Downtown Omaha Residence Inn  
APMA Project #09001  
27 June 2012

ADDENDUM #2

# Downtown Omaha Residence Inn by Marriott

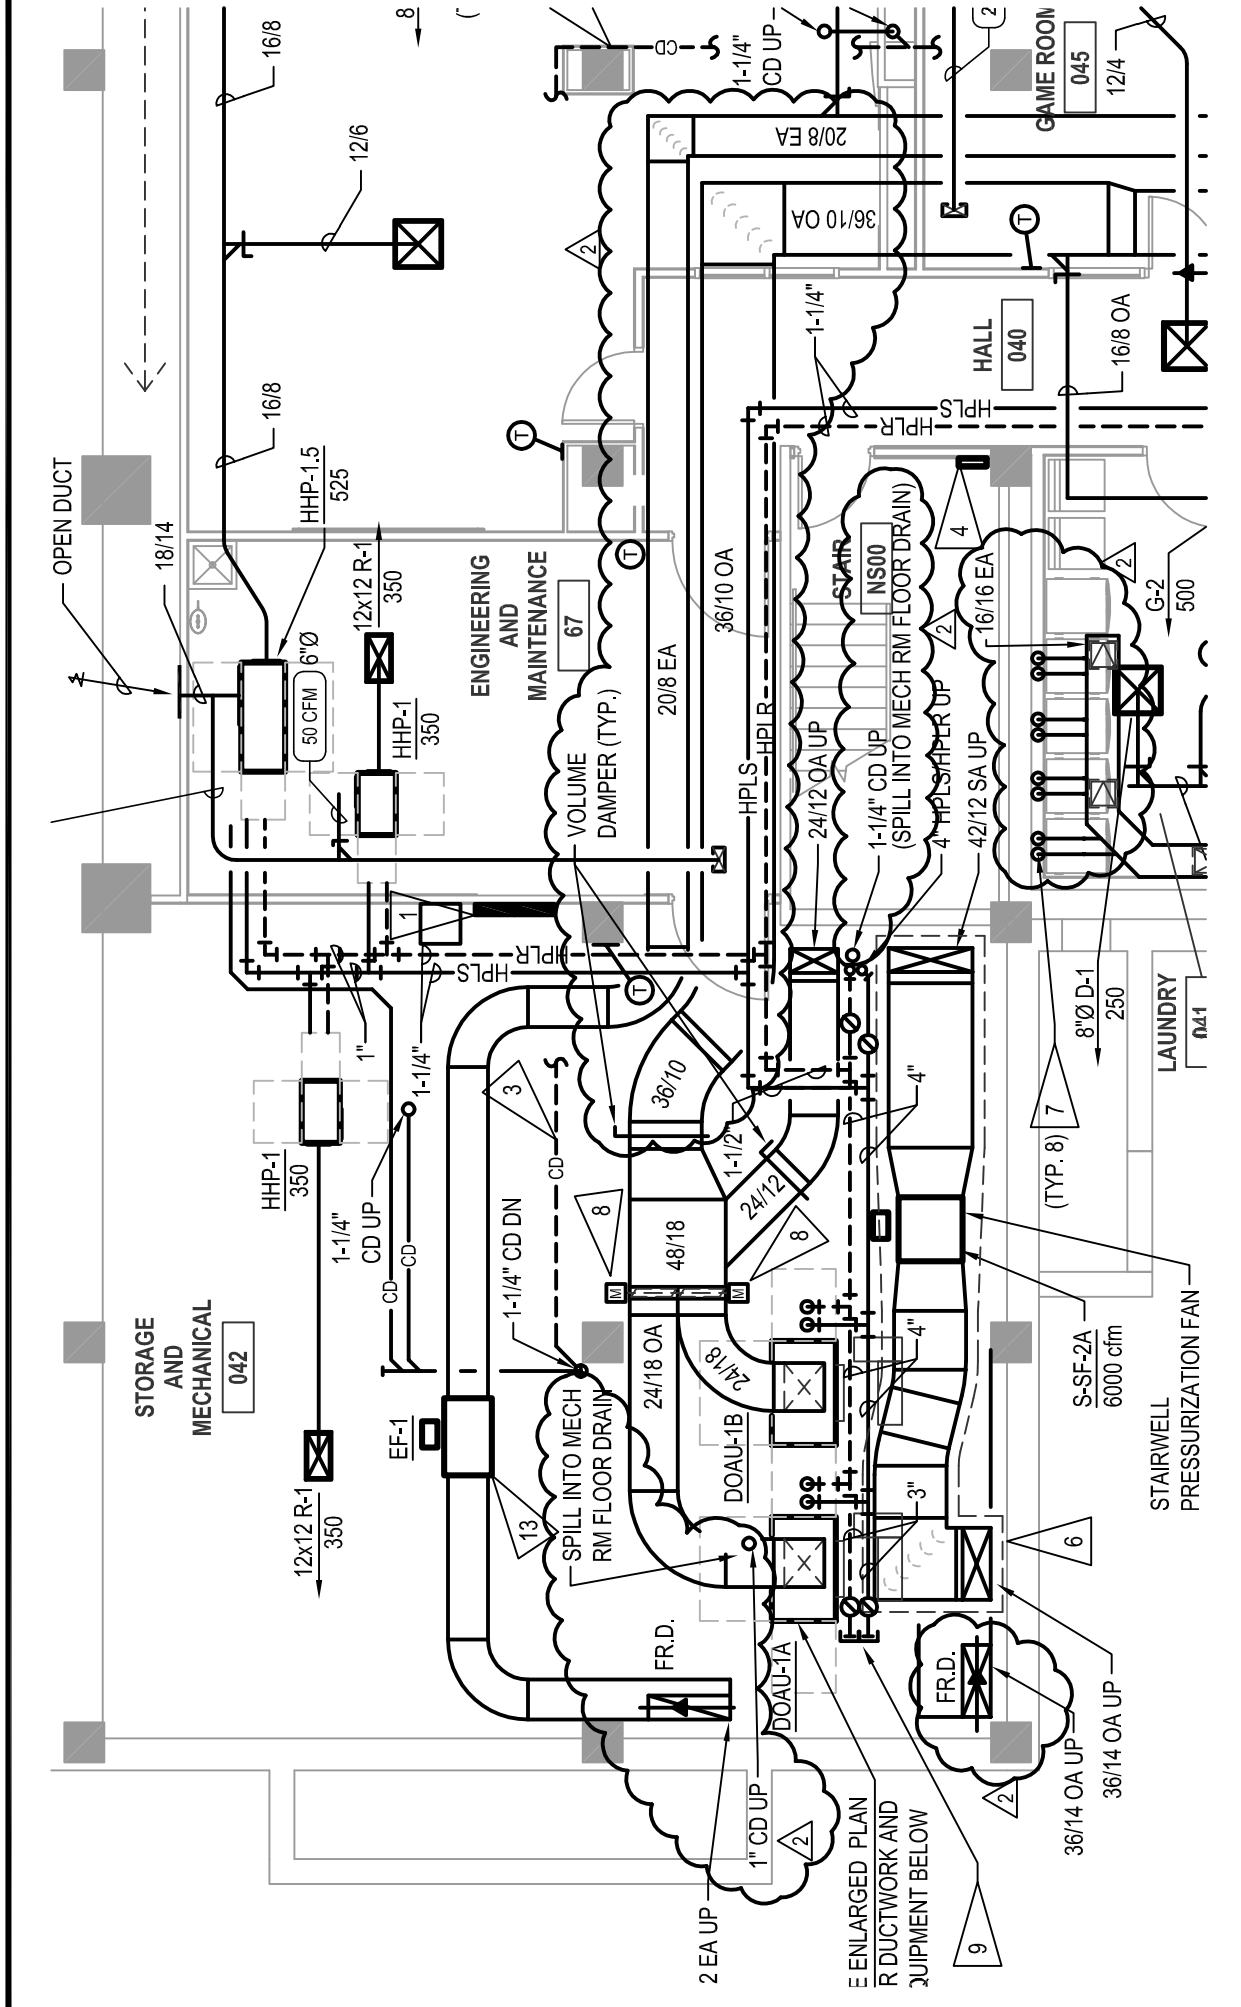
6. Sheet A1.140:
  - a. Plan V1/A1.140. Revise Plan at Bellman's Closet per attached Supplemental Drawings
7. All Suites with Showers:
  - a. Plans H17/A1.404, G17/A4.12, H17/A4.22, M13/A1001.1, G15/A1.1108, H17/A1.1112, V17/A1.1200.1. Add Keyed note a24 "PROVIDE GLASS SHOWER DOOR WITH SIDELIGHT AND TOWEL BAR PULL PER SPECIFICATION. SEE DETAILS ON SHEET A5.30. RETURN MINCEY PANELS AT JAMBS OF OPENING PER DETAILS."

M1.00C

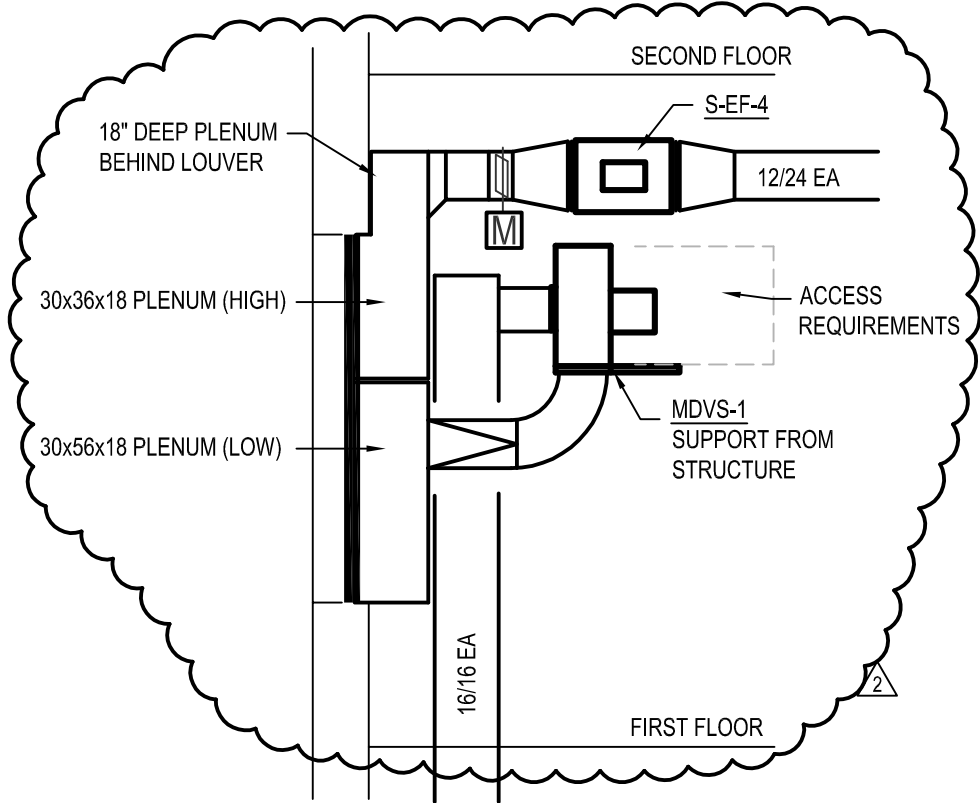
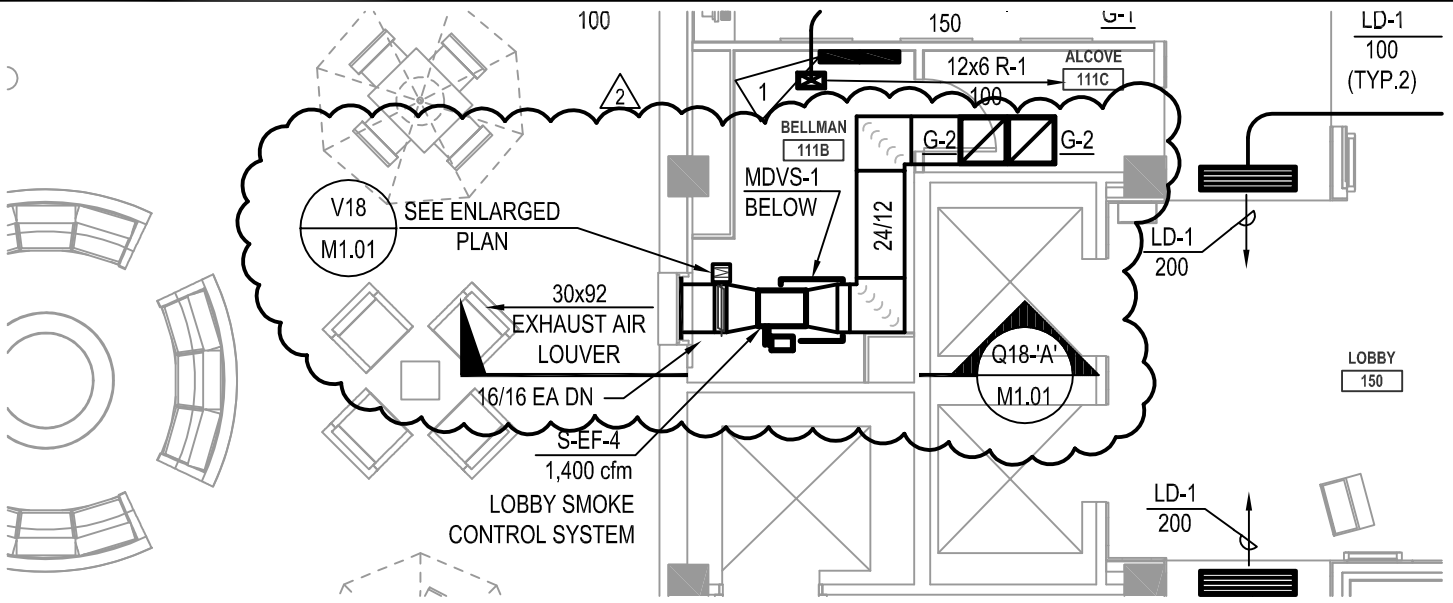
1. Sheet M1.00 BASEMENT FLOOR PLAN-HVAC AND MISCELLANEOUS PIPING
  - a. Storage and Mechanical RM 042
    - i. Provide low leakage opposed blade motorized damper (size 38x16) in 38x14 outside air duct. Interlock damper operation with fan S-SF-2A operation. Provide 12x12 access door downstream for damper position inspection.
  - b. Linen Storage Depot 036
    - i. Provide fire damper in 18x10 outside air duct up. Damper shall be accessible from Linen Storage Depot.
  - c. See Sketch M1.00c

sketch **M1.01a**

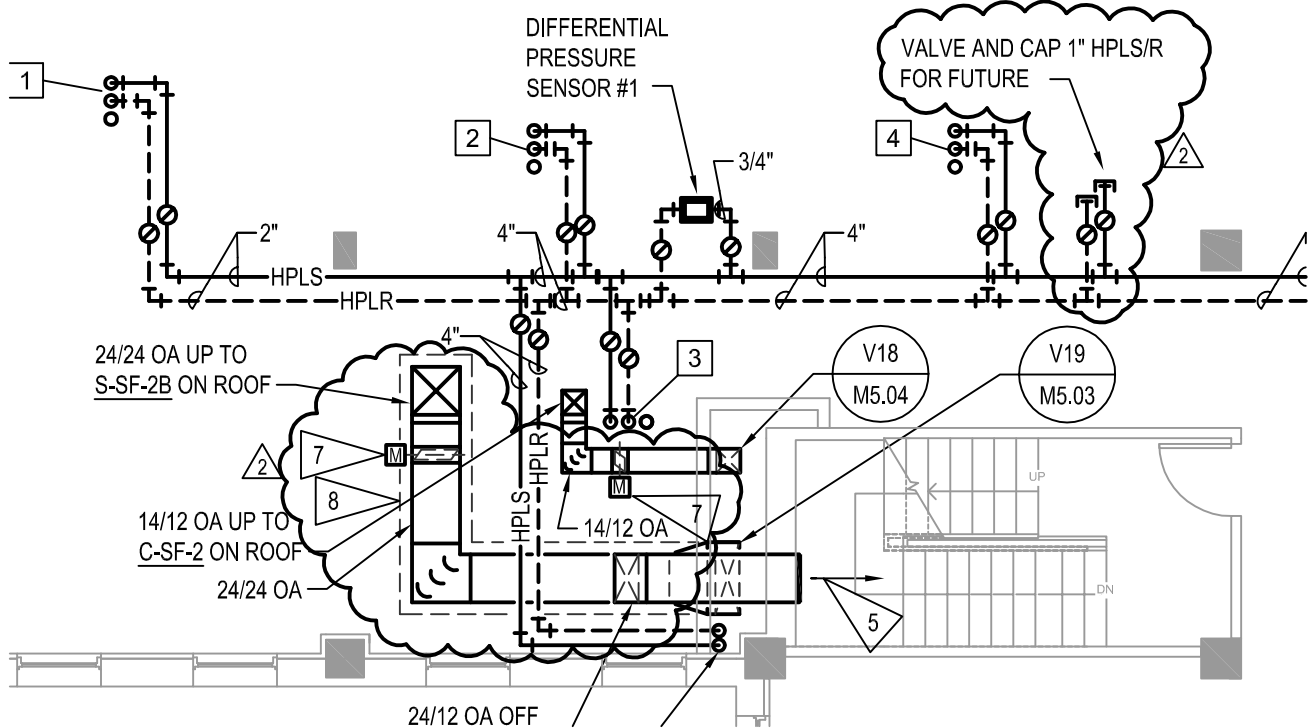
2. Sheet M1.01 FIRST FLOOR PLAN – HVAC AND MISCELLANEOUS PIPING
  - a. Kitchen Rm 143
    - i. Provide heat pump temperature sensor on east wall near door. Coordinate location in field

- b. East Meeting Rm 134
    - i. Provide heat pump temperature sensor on west wall near door. Coordinate location in field.
  - c. Women's Rm 161
    - i. Provide low leakage opposed blade motorized damper (size 48x24) in 48x24 outside air duct. Interlock damper operation with fan S-SF-1A operation. Provide 12x12 access door downstream for damper position inspection.

- e. Market Rm. 151
    - i. Equipment number 624 (glass door merchandiser with remote cooler). Mount remote condenser unit above ceiling. Connect refrigerant piping from cooler to condensing unit complete. Install refrigerant piping per manufacturers recommendations.

- ii. Equipment Number 626 (Glass Door Freezer). Mount remote condenser unit above ceiling. Connect refrigerant piping from cooler to condensing unit complete. Install refrigerant piping per manufacturers recommendations.

- iii. 16/12 return air duct shall be open above ceiling. Install G-1 return air grille to provide air movement across remote condensing units (two) above ceiling.

- f. See Sketch M1.01a

**M1.04b**

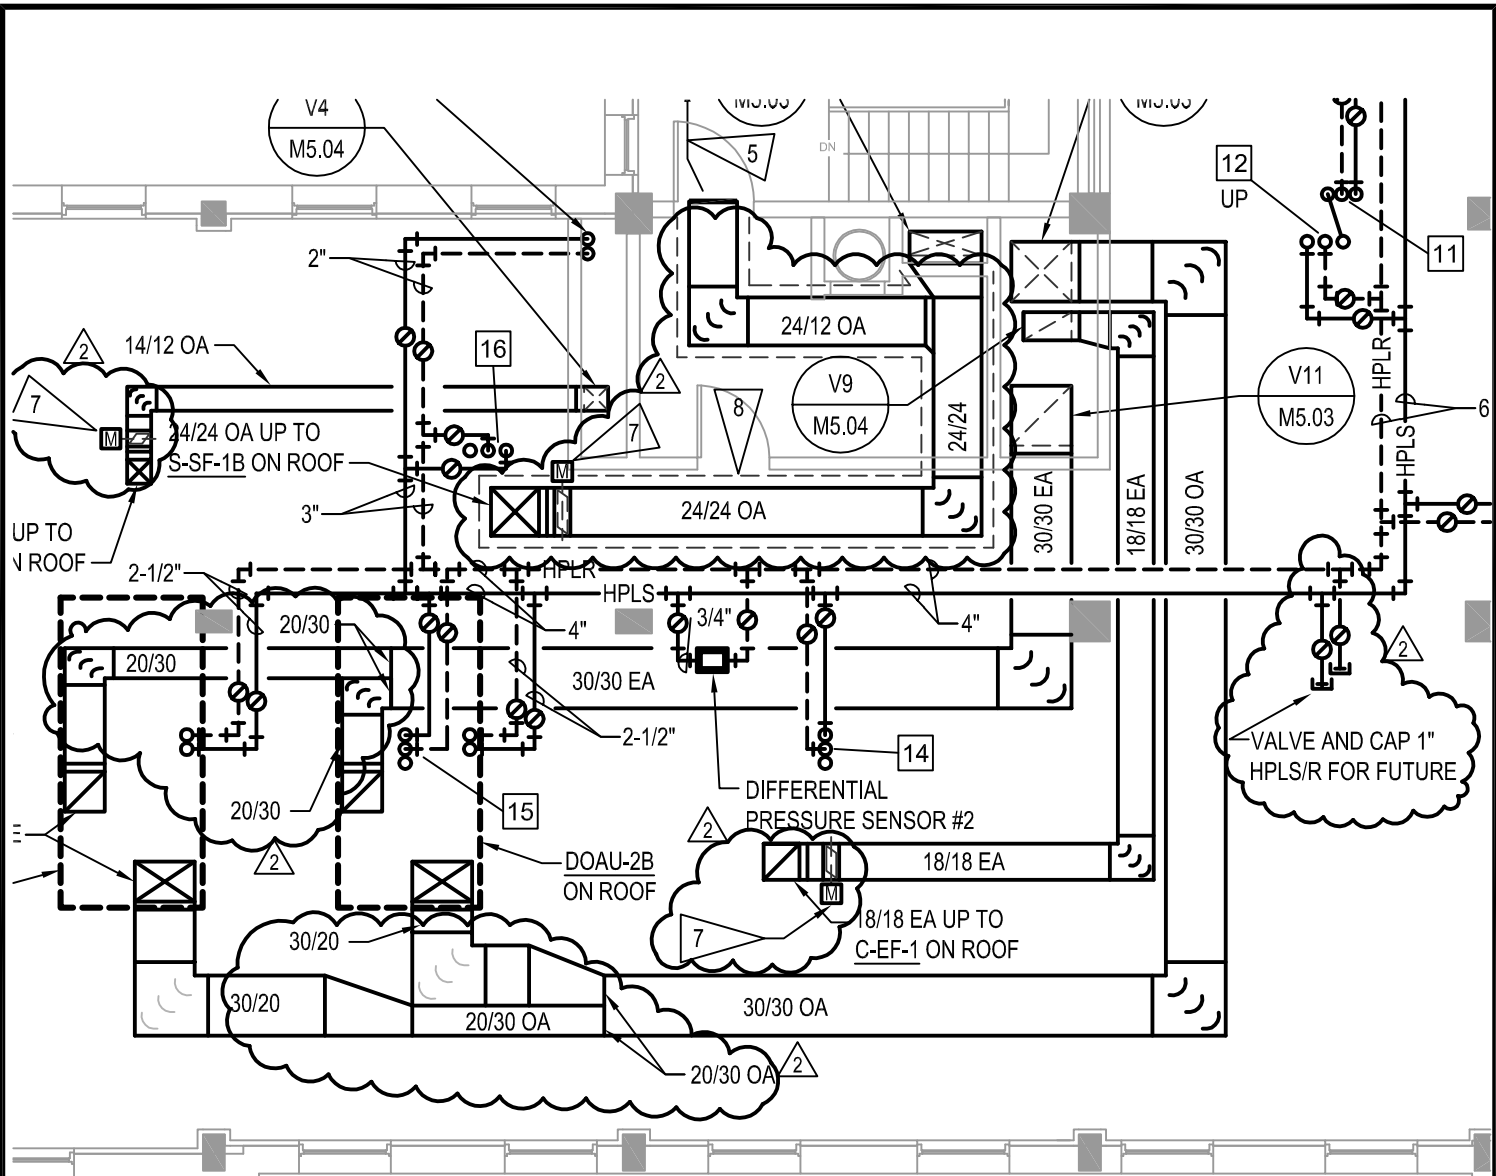
- a. See Sketches M1.04b and M1.04c
4. Sheet M2.00 BASEMENT FLOOR PLAN – PLUMBING
  - a. See Sketch M2.00b
5. Sheet M3.04 TYPICAL FLOOR PLANS – HVAC AND MISCELLANEOUS PIPING

project no.:	11290	drawing referenced:	M4.11
date:	06-27-2012	addendum no.:	2
			M4.11C

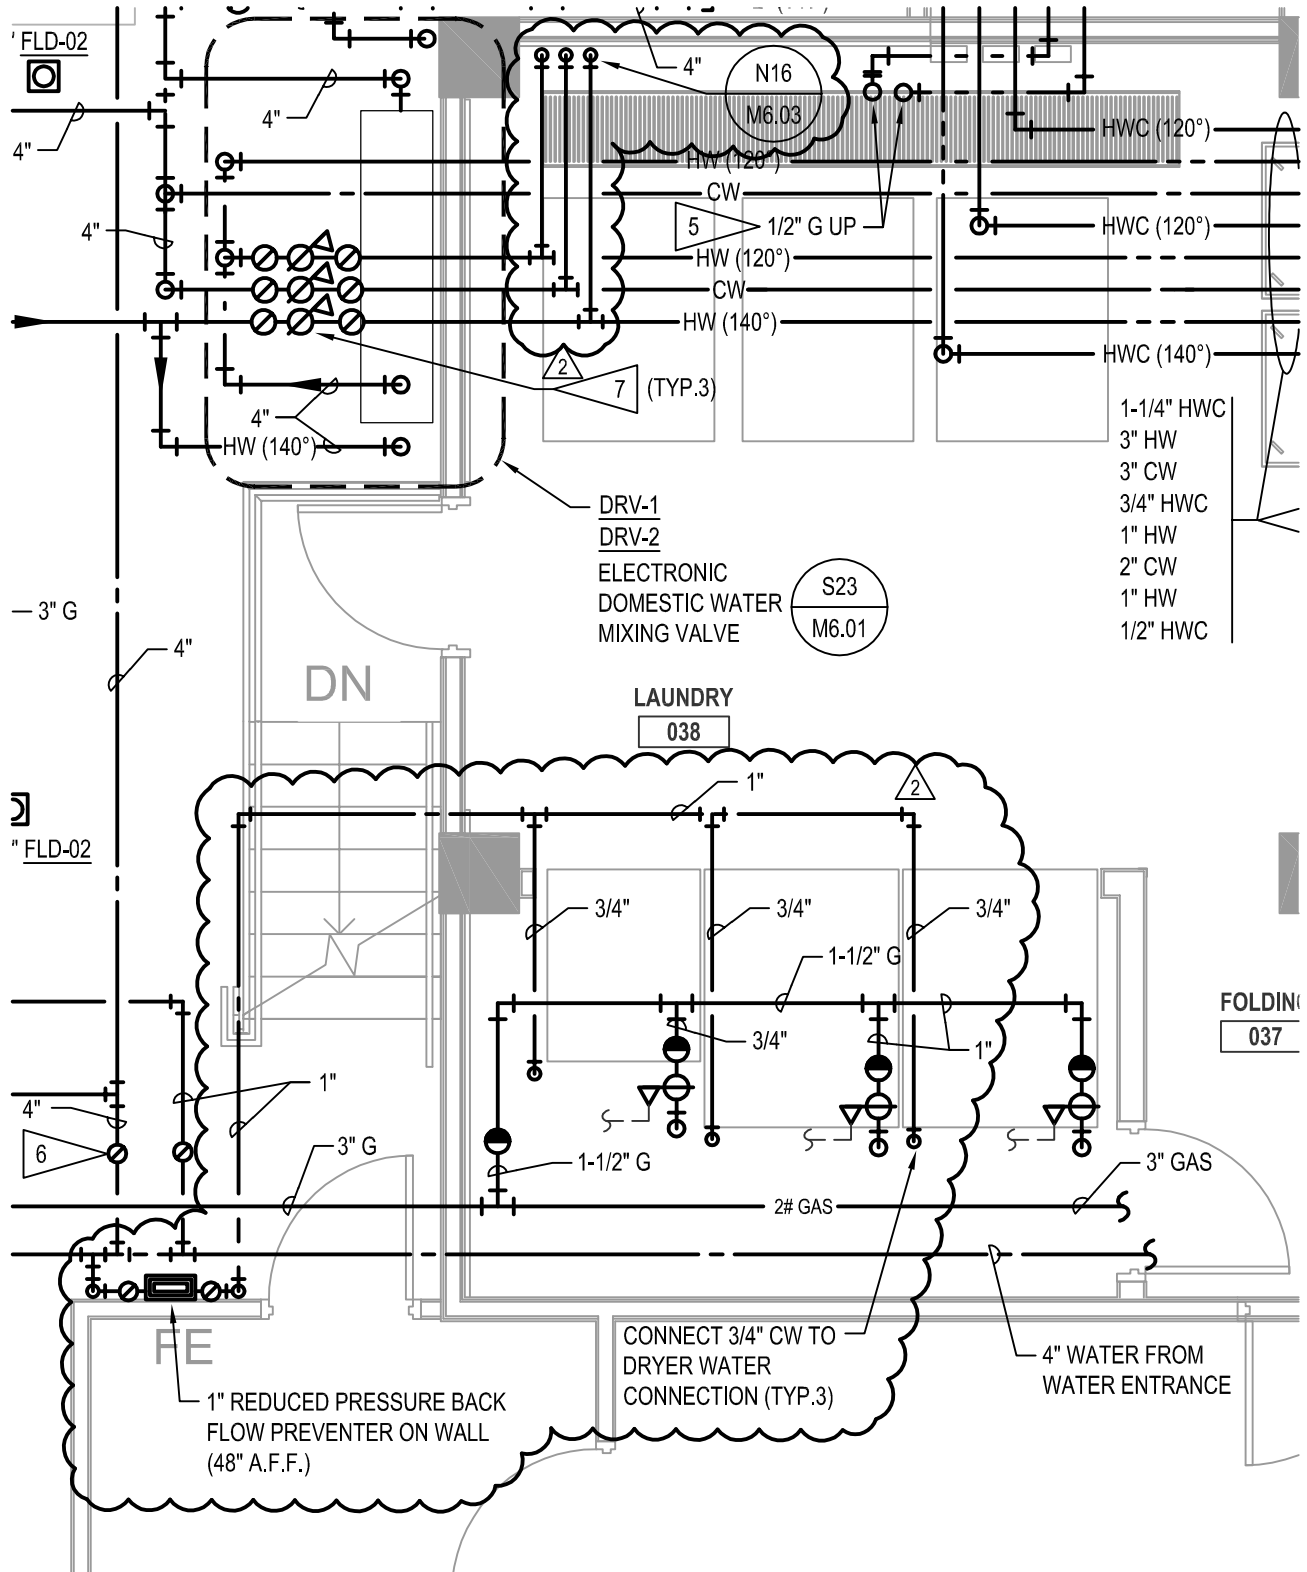
- b. See Sketch M4.05a
9. Sheet M4.10 DOMESTIC WATER RISER DIAGRAM
  - a. See Sketch M4.10a
10. Sheet M4.11 PLUMBING FIXTURE SCHEDULE
  - a. See Sketches M4.11a, M4.11b and M4.11c

sketch **M5.03a**

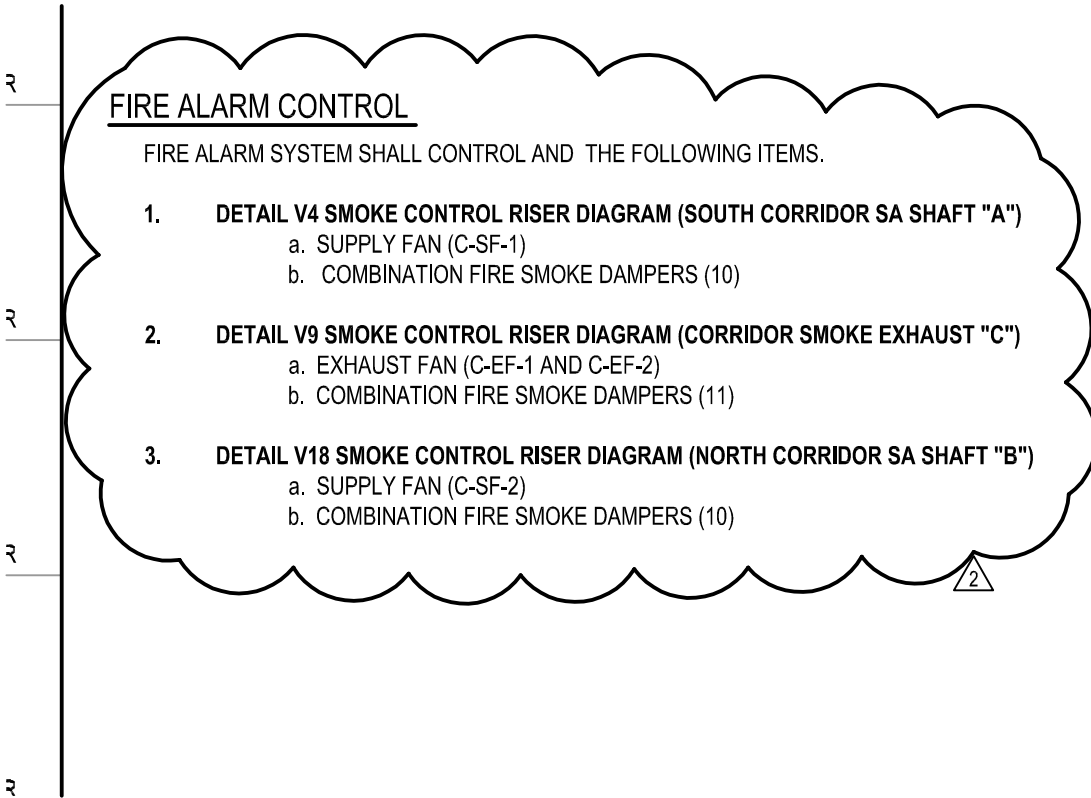
11. Sheet M5.01 ENLARGED MECHANICAL ROOM PLANS
  - a. See Sketch M5.01a
12. Sheet M5.03 MECHANICAL SMOKE CONTROL RISER DIAGRAM
  - a. See Sketch M5.03a
13. Sheet M5.04 MECHANICAL SMOKE CONTROL RISER DIAGRAM
